ENGINE - LP COMPRESSOR - RELOCATE THE FAN BLADE POSITION MARKING INFORMATION ON THE  
BLADE RETAINER - CATEGORY CODE 6 - MOD.ENG-72-0198

V2500-ENG-72-0198

Location of the Front Blade Retaining Ring  
Fig.1

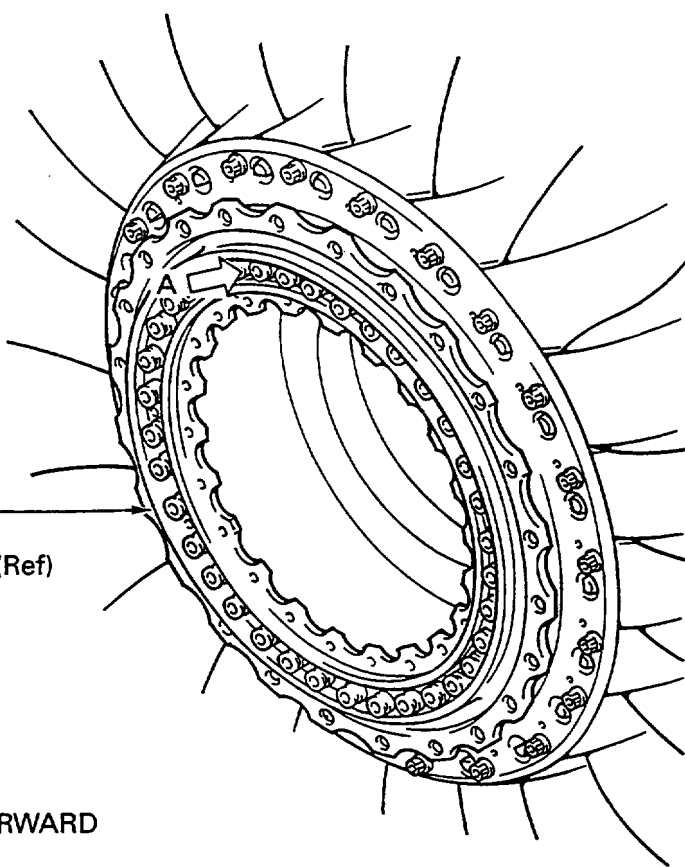
To introduce new identification mark on to the front blade retaining ring in order to enable to identify the fan blade positions without removal of the nose cone A/O.

- (1) Make a blade identification mark "1" to "3" on to the existing front blade retaining ring as follows (Refer to Figure 1 and 2);

Mark the Blade Identification on to the Front Blade Retaining Ring  
Fig.2

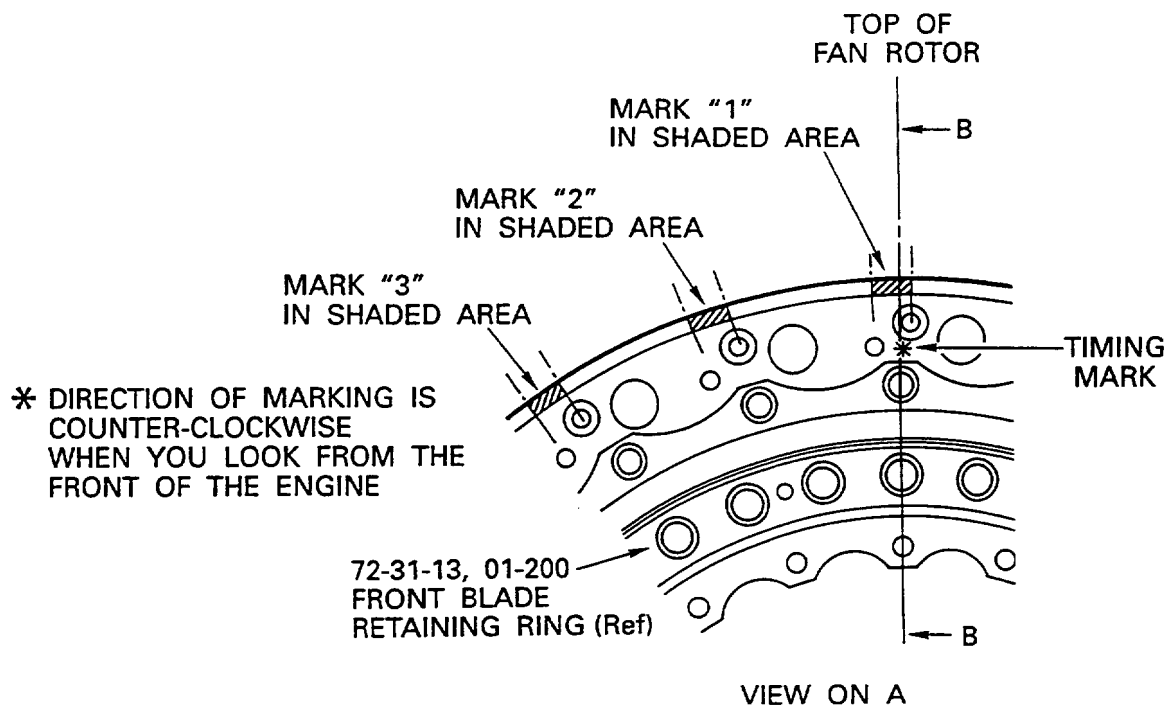
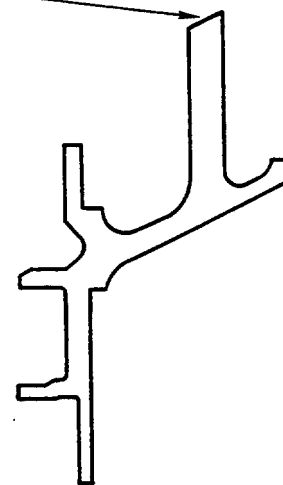
NOTE: Make sure the shaded area which is close the timing marking on the front blade retaining ring, and the outside of timing mark shows the No."1" blade identification mark position. This timing mark is shown by mark "\*" (Refer to Figure 2).

MARK THE No. "1" TO "3" HERE  
BY VIBRO PEEN METHOD  
MARKING SIZE 0.158-0.197  
(4,00-5,00)  
MARKING DEPTH 0.008 MAX  
(0,20 MAX)

- (b) Make a blade identification mark on to the front blade retaining ring, and use the vibro-peen method by approved procedures in Reference (1), Chapter/Section 70-09-00, Marking of Parts.

- (c) Remove the raised metal and burrs produced by above step (b).
